SUBJECT: Forwards stress analysis of drain & fill method for cooling reactor & responses to NRC 800708 ltr re potential effects of rapid RCS depressurization.No excessive stress levels occurred during normal cooldown.

October 17, 1980
L-80-343

RE: St. Lucie Unit 1
Docket No. 50-335
Natural Circulation Cooldown

Figure 1

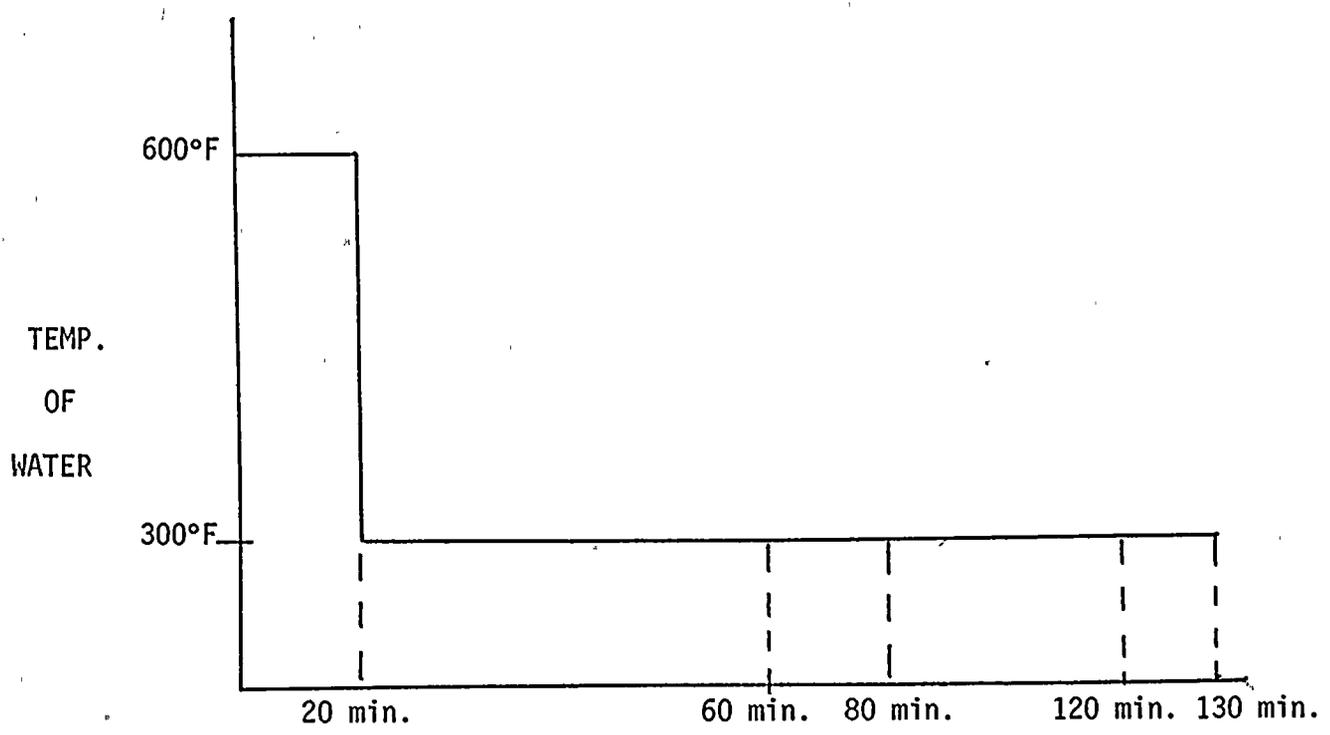
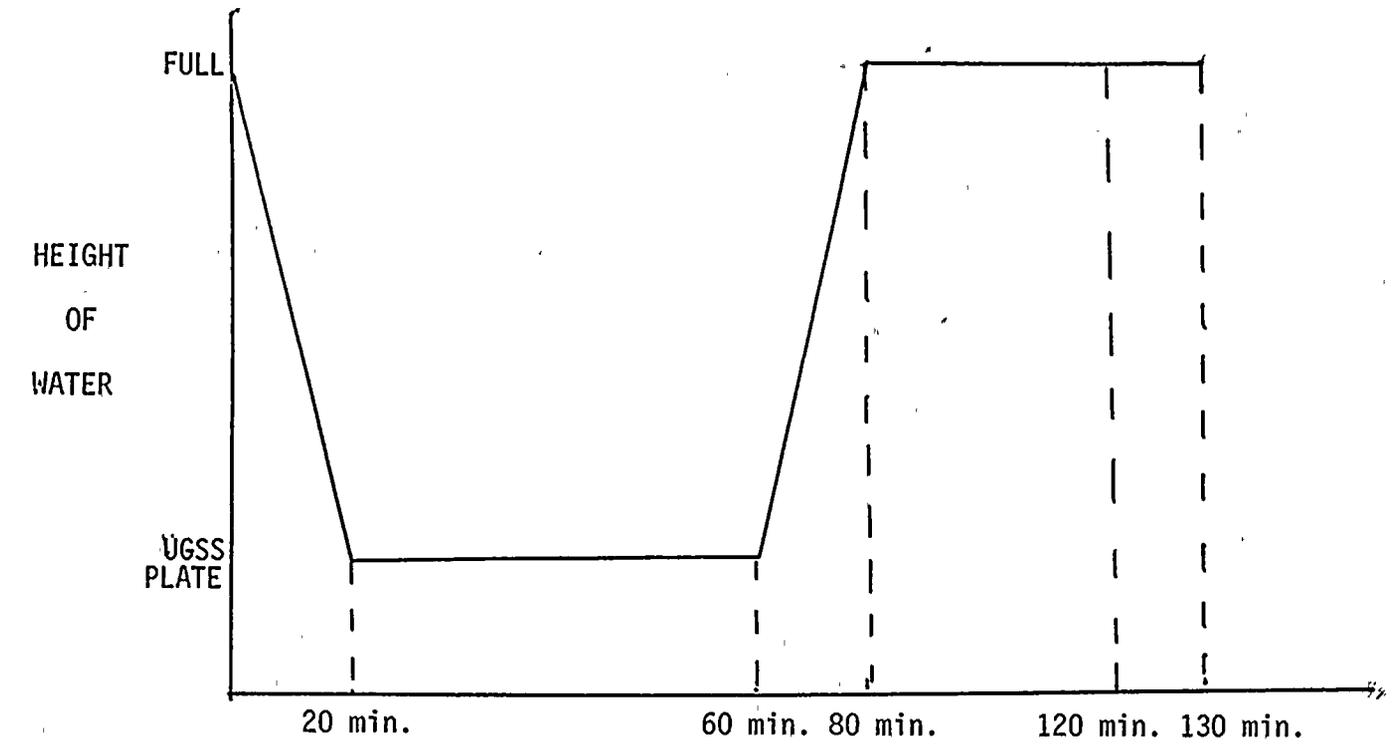
A combined thermal/stress analysis was performed to determine the range of stresses produced in the reactor vessel head due to voiding of the upper head region. In performing the thermal analysis, "worst case" assumptions were made in defining the fluid temperature and initial vessel temperatures. The assumptions which define the thermal transient are as follows and illustrated on Figure 1.

1. The upper head is drained down to the upper guide support structure plate in 20 minutes with both fluid and metal temperatures remaining at 600°F.
2. The water level is held at this height for 40 minutes with a fluid temperature of 300°F.
3. The head is refilled over a 20 minute period with 300°F water.
4. The upper head remains filled with 300° water for a period of time.
5. The heat transfer coefficient for the water is large ($H=500 \text{ Btu/ft}^2 \text{ - hr-}^\circ\text{F}$).
6. The heat transfer coefficient for steam is very small ($H=0. \text{ Btu/ft}^2\text{-hr-}^\circ\text{F}$).

Temperatures calculated for this transient were applied to a stress analysis model. The results of this analysis indicate that the highest stresses occur in the "knuckle" region of the head near the inside radius. The magnitude of stresses produced for this transient were found to be no more severe than the stresses occurring during a normal cooldown of 100°F/hr.
